Proposed development: Hybrid planning application comprising - Full permission for the erection of 160 dwellings and 50 affordable, key hospital worker apartments in two blocks together with access roads and landscape treatment (Phase 1); and outline permission for the erection of 100 affordable, key hospital worker apartments in four blocks, with all matters reserved except for access (Phase 2).

**Land Bounded by Haslingden Road and Fishmoor Reservoir
Haslingden Road
Blackburn**

Applicant: Keepmoat Homes

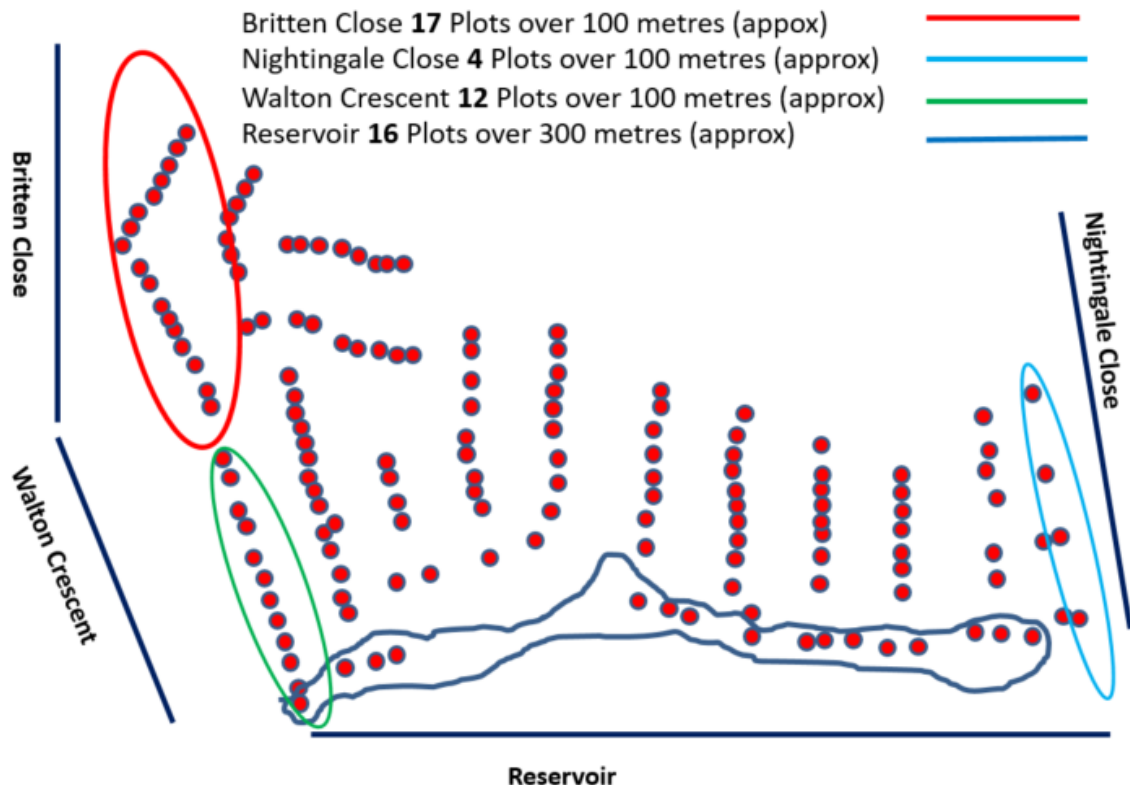
There seems to be a concentration of houses at the rear of us and less space as in other areas of the plan.

We can't see how its possible for Hx semi's to be built from the side of us 20 Britton Cl. to the back of ours no. 14!.

Ref Figure 3 of Flood Risk Assessment Plan

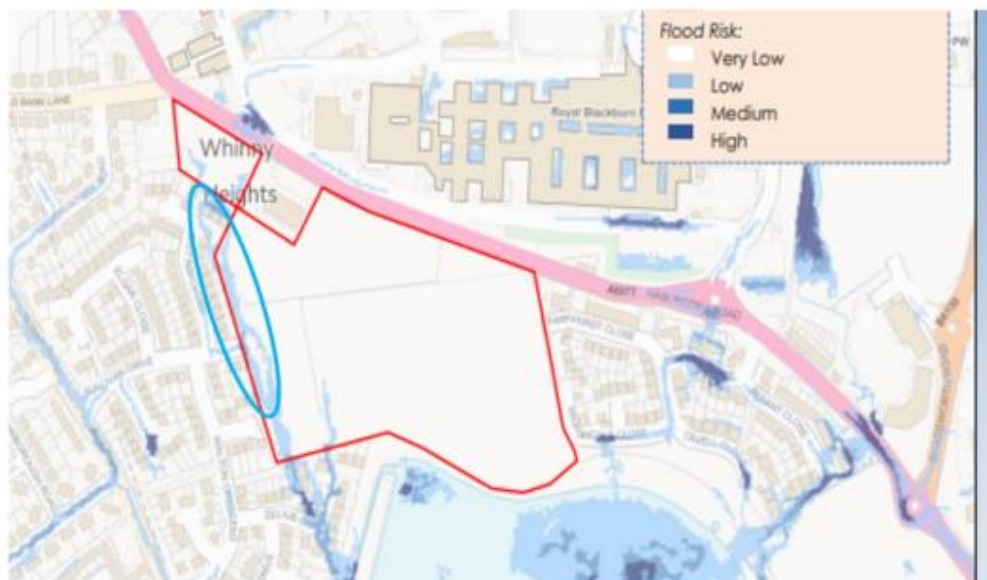
4 The Environment and Flood Risk Strategy Document for this development clearly shows surface water 'Risks' running along the entire Western Boundary (Britten Close and Walton Crescent). See Page 5 and 6. These risks are clearly identified in the document Ref Para 4.4.3 of the document and state "conveyance routes where present to be maintained is also recommended, particularly in those locations where surface water risks are currently illustrated" These risks have Not been mitigated by the developer in the area around the upper part of Britten Close, as there is no separation between the developments as there is along the boundary at Walton Crescent. However, it looks like at some point in the design stage this was not the case as looking at the Street Scene view Section 2-2 Keepmoat Dwg KMNW DR A 13000 Locator View Street Scenes, the boundary line on this drawing shows separation of the developments all the way along the Western edge . See page 7

This Western Boundary Surface Water Run Off is in fact the origins of the Higher Croft Brook which flows down the western boundary of the development and enters the Reservoir overflow runway behind Delius Close. During wet weather the whole western edge of this development 'flows' and floods the road at the lower part of Sullivan drive at its boundary with this new development.

If this development goes ahead then the ditch along the western edge should be re-defined to aid the flow of this surface water run off for the full length of the development. From the top of Britten Close, along Walton Crescent and down to Delius Close with adequate separation between developments around the conveyance route as requested by the Flood Risk document. This would also enable the people on Britten Close and the new development, to maintain their fences without the need for 'party' fencing as is planned currently.
